**GEORGETOWN-SCOTT COUNTY PLANNING COMMISSION**

## TRI-VILLAGE STORAGE

### Staff Report to the Georgetown-Scott County Planning Commission

**FILE NUMBER:** PDP-2019-04

Figure 1

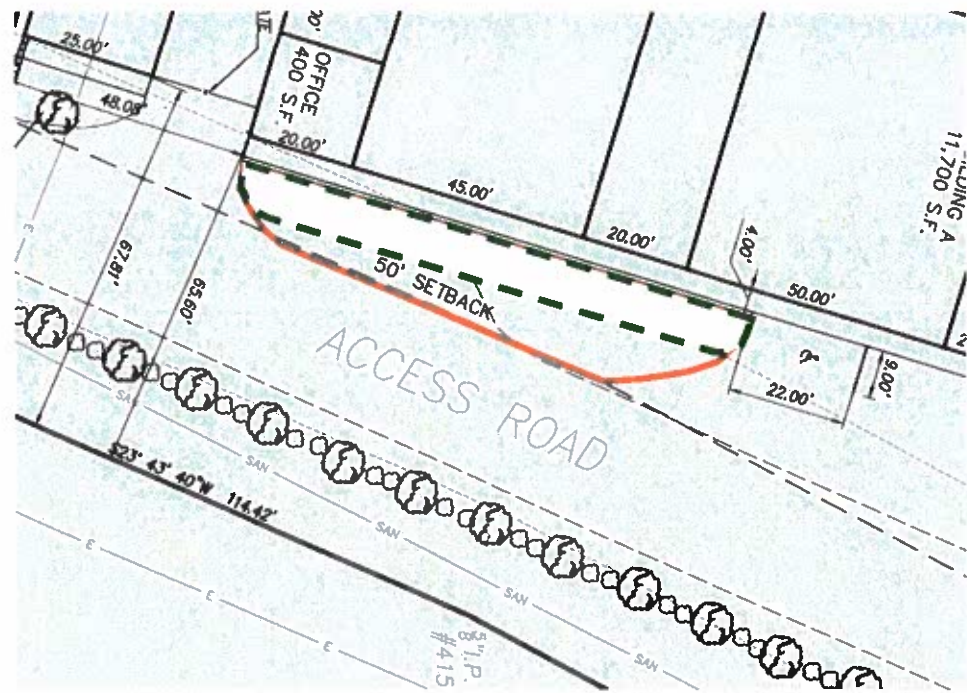
This Preliminary Development plan proposes three entrances to the Project Site from the access road. The two main entrances are roughly 20 feet and 32 feet in width. The third, and central, entrance to the Project Site provides access to several parking spaces and is roughly 71 feet in width. Section 1005 (C.2) of the *Subdivision & Development Regulations* states, "street entrances to commercial developments shall be no wider than ¼ of the lot width up to a maximum width of 40 feet." Subsection C also goes on to require barriers to prevent "random vehicular access." Approval of this plan would require a variance to the maximum width for an entrance to a commercial development. Staff recommends the Applicant extend the proposed landscaped area in front of the office to better define the entrance to the Project Site and better prevent random vehicular access to the road. Looking at Figure 1 below, the green dashed line is the Applicant's proposed landscaped area, and the orange line represents staff's recommendation. This would not eliminate the variance required for this development but would more clearly define the entrance from the access road.

As of the writing of this report, staff is still awaiting comments from the Fire Department regarding their ability to navigate through the development should there be an emergency. Staff has included a condition requiring the Applicant to comply with all requirements of the Fire Department.

**SITE PLAN**

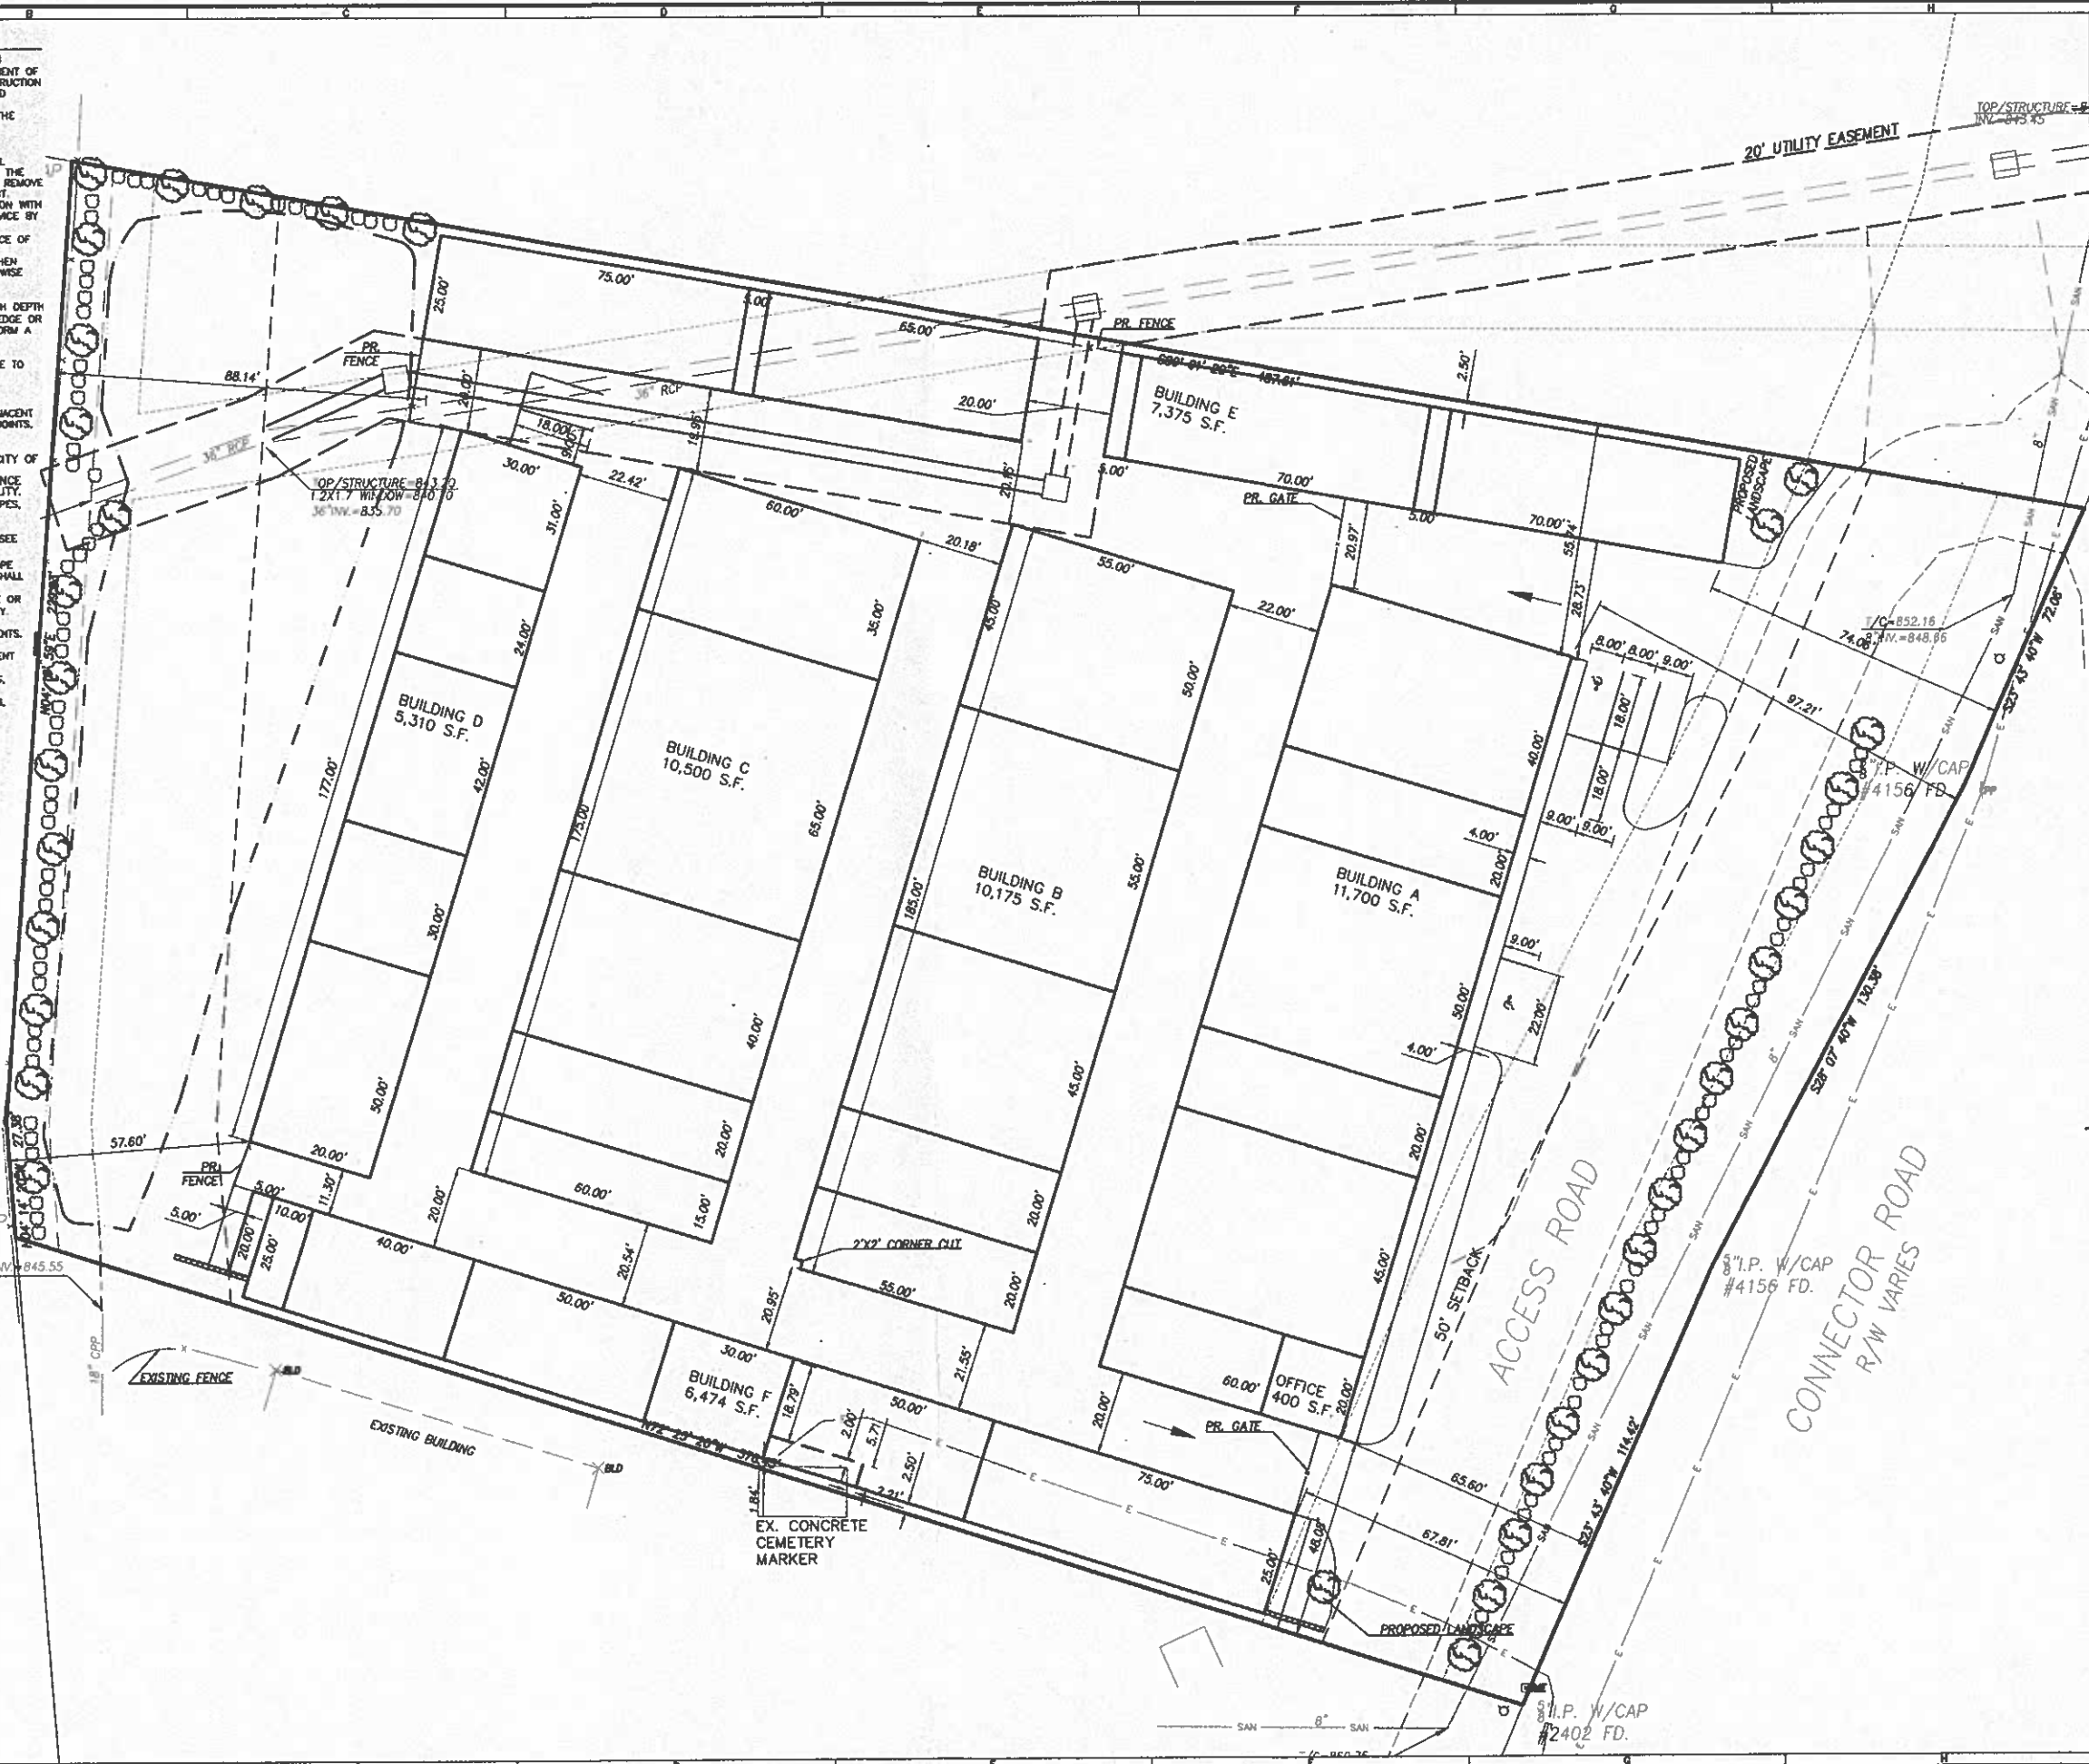
**Parking Spaces:** The parking standard for self-storage units in the *Subdivision & Development Regulations* is one (1) parking space for every ten (10) storage units. The proposed plan will create roughly 337 storage units, which requires 34 parking spaces. The Applicant is proposing a total of 8 parking spaces to serve the Project Site. The proposed parking should be sufficient to serve the needs of the facility's office but does require a variance. Additionally, the majority of clients visiting the site will not require a parking space, because they will park in front of their storage unit. The parking spaces shown on the interior of the project site might be better located in the gap in Building E created by the utility easement.

One of the parking spaces created near the entrance to the Project Site only measures 7 feet in width and does not meet the requirements for even a compact space. This space and the two spaces adjacent could be reconfigured into 2 compact spaces and one regular space.

Proposed buildings along the northern and southern property boundaries will mostly screen the VUA from the adjoining properties. The gap in Building E will need a landscaping buffer to screen the VUA from the adjoining property to the north. This buffer shall be populated in accordance with section 6.13 of the *Landscape and Land Use Buffers Ordinance*. The Applicant is proposing some screening between the access road and Connector Road to screen the VUA from Connector Road. There is no landscaping present on the development plan to screen the parking areas from the private streets. The Development Plan from 2017 allowed for the landscaping between the parking area and the access road to be waived as long as the landscaping between the access road and Connector Road was provided, as shown on this Development Plan

The site statistics provided with the development plan do not specify how much VUA and interior VUA landscaped area is proposed with the development. The Applicant is working to supply staff with this information, but at the time the staff report was written, sufficient information was not available. On a visual examination, the development plan does not appear to meet the 10% requirement for interior landscaped area. Without appropriate site statistics, staff cannot accurately determine if the proposal needs a variance or not.

For the 2.79-acre site, a total canopy coverage of 29,168 square feet is required (24% new canopy). A total of 37 trees are being proposed, which is not sufficient to meet the required canopy coverage. Even with all large trees, 37 trees only provide 27,750 square feet of canopy. The applicant will need to meet the canopy coverage with a specie-specific final landscape plan at the time of Final Development Plan.

- a. Creating a landscaping buffer in the gap in Building E;
  - b. Adding additional trees to meet the 24% canopy coverage requirement,
  - c. Correcting the size of some of the parking spaces shown,

- d. Various incorrect labels on the measurements of buildings.
3. No justification has been given for the variances, except the parking reduction. Typically, there must be special conditions peculiar to the lot, land, or building(s) in question. The Applicant must also demonstrate that a literal interpretation of the ordinance or regulations would deprive them of rights enjoyed by other property owners, and that any special conditions do not result from previous actions of the applicant.

1. Variance to reduce the required parking to 8 spaces.
2. Variance to increase the maximum width of a street entrance to 71 feet.
3. Waiver to eliminate the screening requirement for screening the VUA from the access road.

5. Prior to (as part of) the Final Development Plan approval, the applicant shall provide the Planning Commission staff (GIS division) with a digital copy of the approved plan.
6. Prior to any construction or grading, a Final Development Plan, including all required construction plans, shall be approved by the Planning Commission staff and the applicant shall schedule a Pre-Construction Meeting with the Planning Commission Engineering Department to review construction policies and to establish inspection schedules. This includes a Grading Permit with fee and a Land Disturbance Permit with erosion control surety.
7. A final specie-specific landscape plan shall be provided along with the Final Development Plan. The landscape plan shall meet the canopy requirements.
8. A landscaping buffer shall be included in the gap in Building E.

PRELIMINARY DEVELOPMENT PLAN  
SOUTH CROSSING APARTMENTS  
McCLELLAND CIRCLE  
GEORGETOWN, SCOTT COUNTY, KENTUCKY

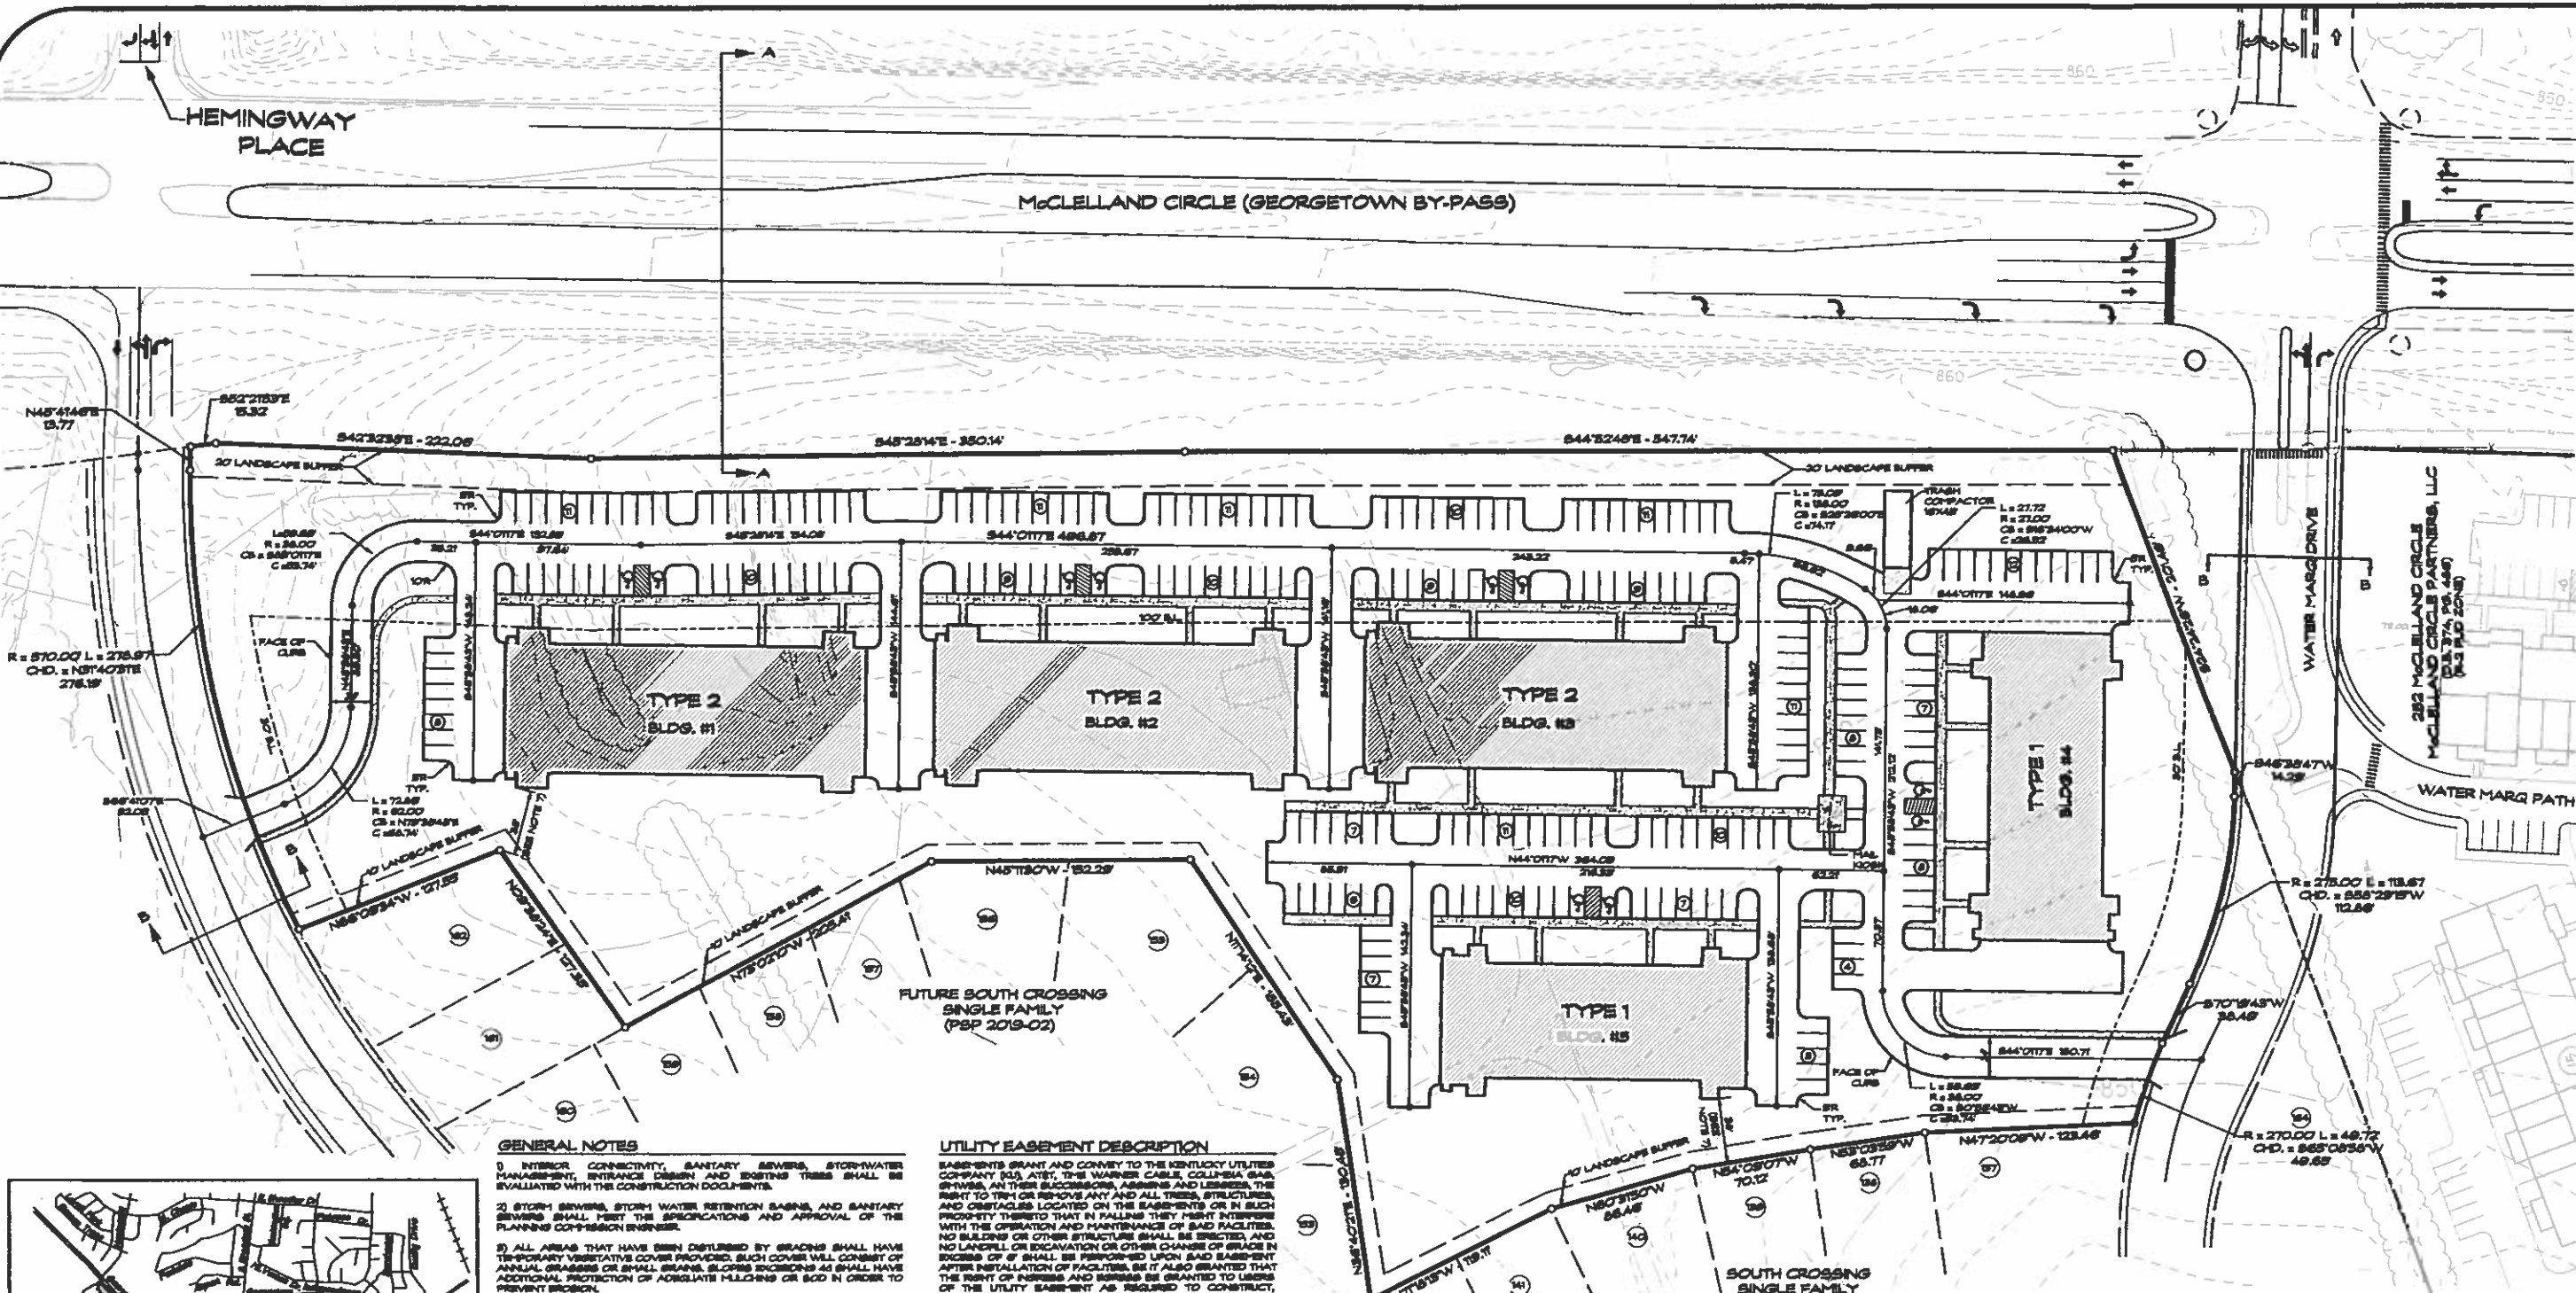
The buildings exceed the allowable height by eight feet. Each building is proposed thirty-eight feet high instead of the maximum thirty feet. The Zoning Ordinance does allow for the extra height if additional setback is provided. The applicants are providing thirty-eight feet of rear setback from the closest building to the property line.

The applicants are requesting waivers as part of PUD approval for the three-story building type and for the number of dwelling units per building. There are two building types proposed, one with 28 units and one with 24 units. The maximum number of units per building in the standard R-2 District is six (6) units per building.

Two entrances are proposed to the multi-family area from the two public access roads. The entrance roads are designed to accommodate a turn lane into the apartment area. The private entrance roads themselves are 24' wide. No turn lane out is proposed and there is plenty of stacking distance. The Planning Commission Engineer has requested that the private drives/roads to the apartment buildings be increased to 26' and turning movements be documented at time of Final Development Plan submittal.

288 parking spaces are required based on the standard of 1.5 spaces per 1 bedroom unit and 2.5 spaces per 2 and 3 bedroom unit. The applicants are providing 302 spaces, 242 surface spaces and 60 garages, 12 garages per building. Sidewalks are shown internally in front of the buildings and to mail and garbage facilities on site and from the eastern entrance to the Marketplace intersection.

The applicants have submitted a landscape plan that shows they can meet the required internal and perimeter VUA landscaping requirements. They are also providing a landscape buffer between the multi-family area and the single-family lots in the form of a 10' landscape buffer with a tree every 40-foot and a 6-foot high wood privacy fence.

1. Exceed the building height in the R-2 PUD apartment area to 3 stories and 38 feet.
2. Increase the number of apartment units per building in the R-2 PUD apartment area from six (6) per building to twenty-eight (28) per building.

4. Private driveways to apartment area shall be a minimum of 26' width and meet minimum requirements for turning movements.
5. All requirements of Georgetown Fire Department.
